#### Regulation No. 90 (Replacement brake linings)

## **Proposal for amendments to Regulation No. 90 (Replacement brake linings)**

### **Submitted by the experts from Italy\***

The text reproduced below was prepared by the experts from Italy to introduce, in the text of Regulation No. 90, requirements for the approval of replacement brake discs for L-category vehicles. The modifications to the existing text of the Regulation are marked in bold for new or strikethrough for deleted characters.

"3. **Brake disc design types for L<sub>1</sub>, L<sub>2</sub>, L<sub>3</sub>, L<sub>4</sub> and L<sub>5</sub> categories** (examples)

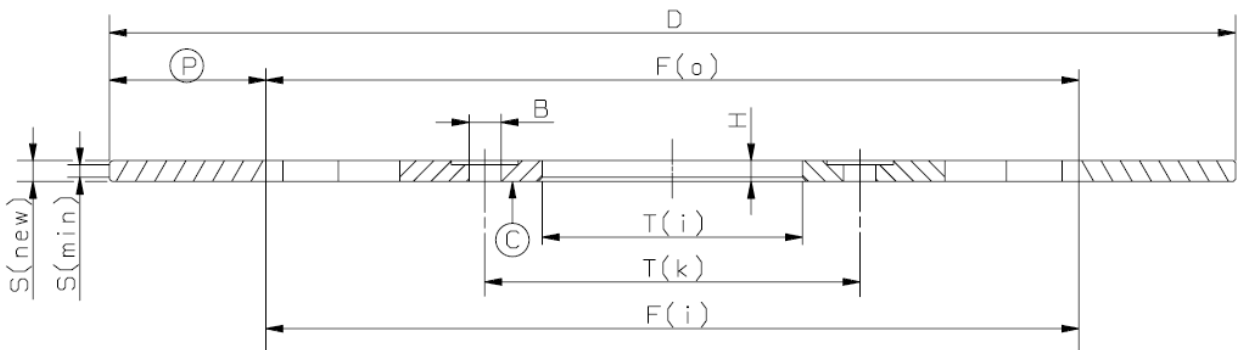
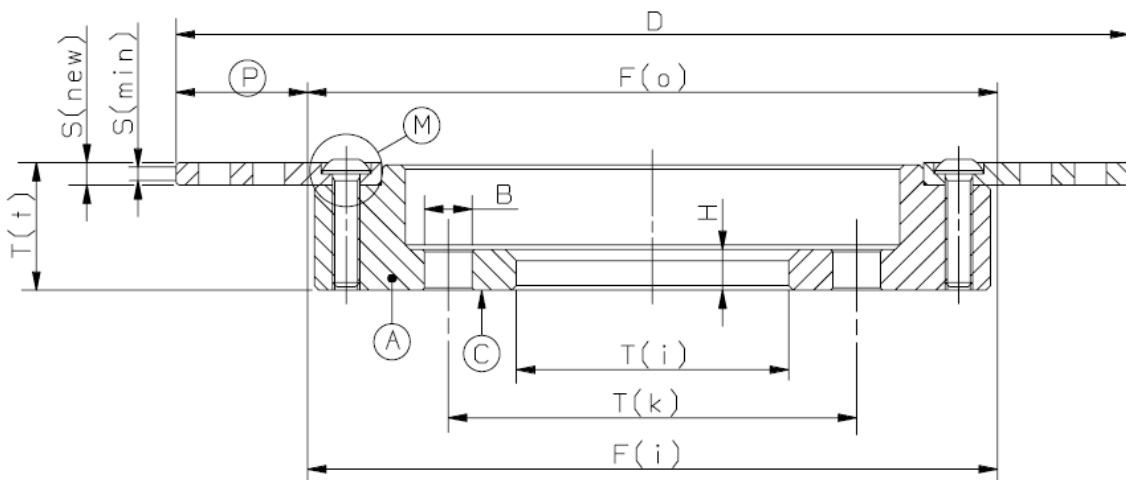
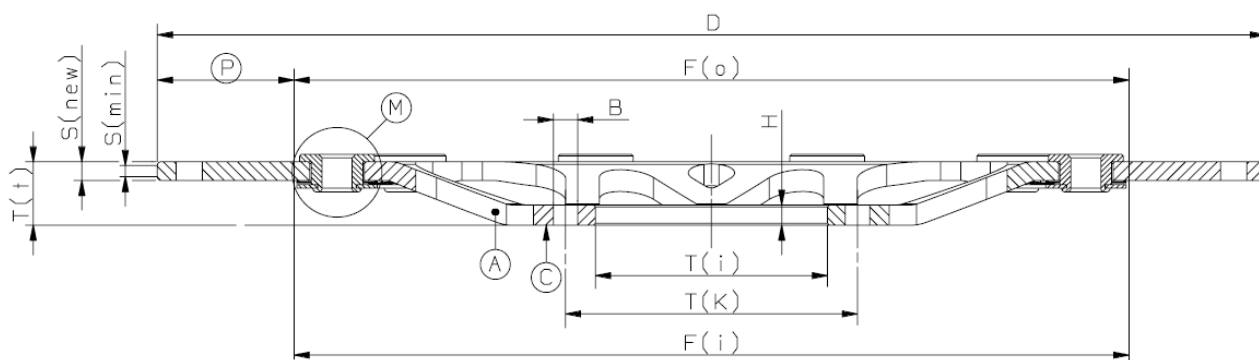
*Add a new paragraph 3., to read:*

**One-piece type: brake disc with braking surface and bell made in a single piece and, therefore, of the same material**

**Composed fixed type: brake disc having the braking ring made of steel, while the bell is of other material, generally aluminium; the 2 components are rigidly bounded by a screwed or riveted connection.**

**Floating type: brake disc having the braking ring radially released from the bell, in order to allow its thermal expansion.**

Figure 1

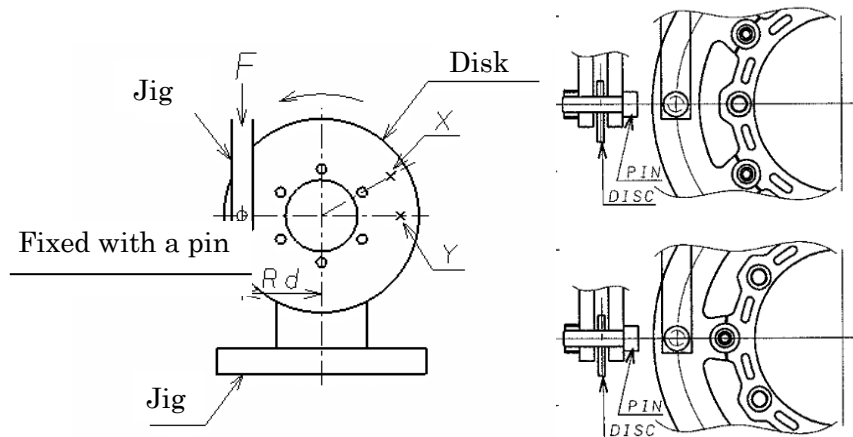
To verify the resistance of the bell and, in case of floating discs, of the connection system to the braking ring when the disc is subjected to a braking torque.

Static test performed on special test bench shown in Fig. 1.

**Figure 2**  
**Movement**

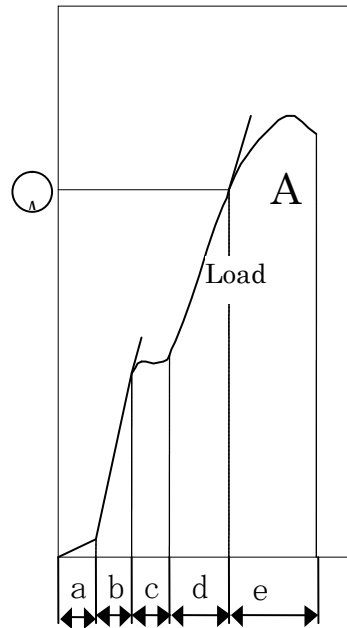
- (a) Adjustment stroke of the equipment (recovery of any clearance between the hole on the braking surface and the connection pin to the bench arm);
- (b) Load developed by the fastening screws to the equipment;
- (c) Movement of the brake disc caused by its rotation with sliding on the plate of the equipment, when the disc's fastening screws bear against the fixing holes of the disc;
- (d) Load supported by the brake disc;
- (e) Permanent deformation of the brake disc (starting from point A).

The disc does not have to undergo permanent deformations before reaching the force  $F$  specified in Table A14/2.2.5; the measurement of the deformation force must be performed at point A as in Fig.2.

Figure 3

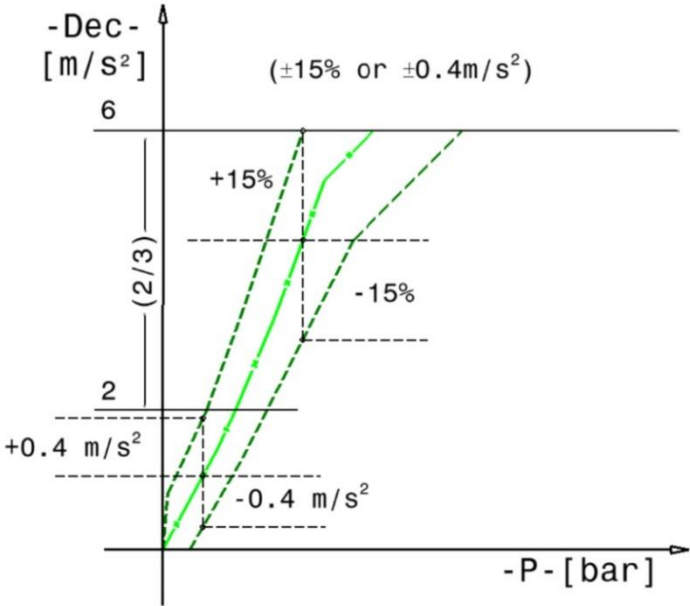
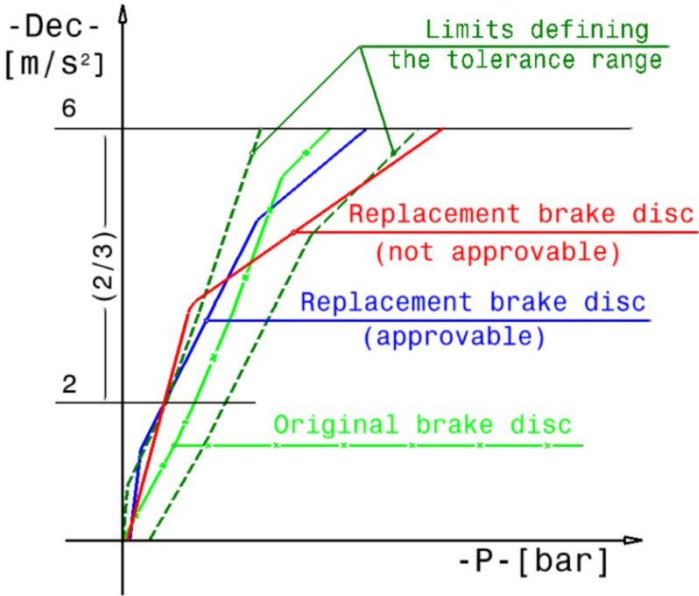
- 3.2.6.4.** The dynamic frictional properties of the replacement brake disc can be regarded as similar to those of the original brake disc, provided the values attained in relation to the mean fully developed deceleration at the same operating pressures or control forces in the region of the upper 2/3 of the curve generated do not deviate by either  $\pm 15$  per cent or  $\pm 0.4$  m/s<sup>2</sup> from those of the original brake disc (see an example of the curve in Figures 3 and 4).

Figure 1

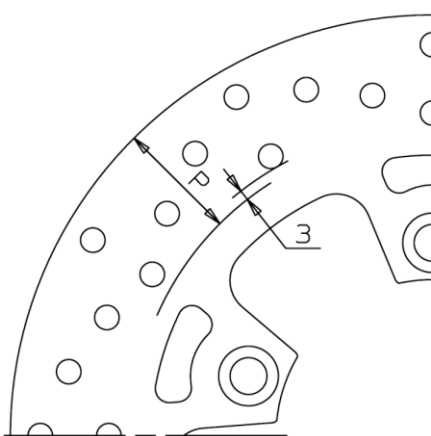
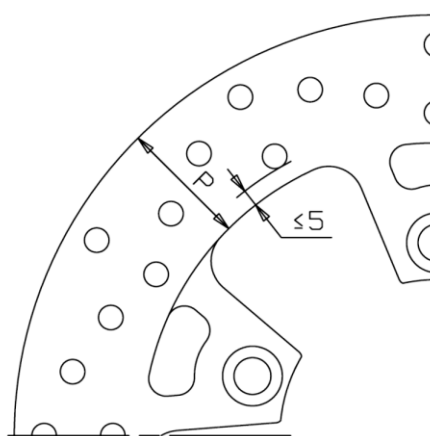
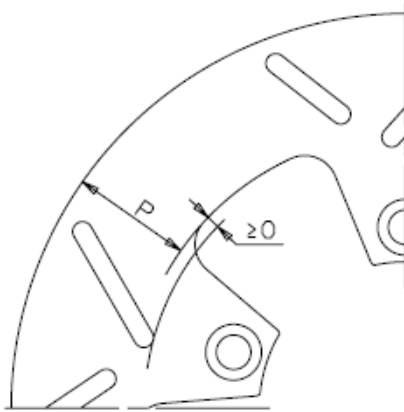
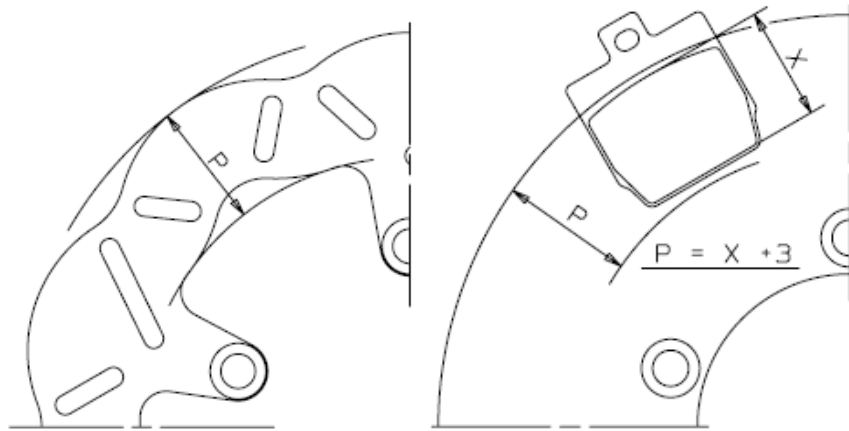
Braking surface means the surface of a brake disc on which the brake pads work. The braking surface width is calculated between the disc outer diameter and an internal diameter defined as follows:

- 1.1. Case of braking surface with lightening (holes, slots, wave, etc.) on the braking surface (Fig. 1) only: 3 mm towards the centre of the disc from the end of the lightening.
- 1.2. Case of braking surface with lightening (holes, slots, wave, etc.) with distance from the disc's internal diameter lower than 5 mm (Fig. 2): diameter of the brake disc undercut.
- 1.3. Case of braking surface with lightening (holes, slots, wave, etc.) which terminate inside, outside the brake disc undercut (Fig. 3): diameter of the brake disc internal undercut.
- 1.4. All other cases: internal diameter defined by the radial width of the largest combinable pad, to which 3 mm need to be added (Fig. 4).
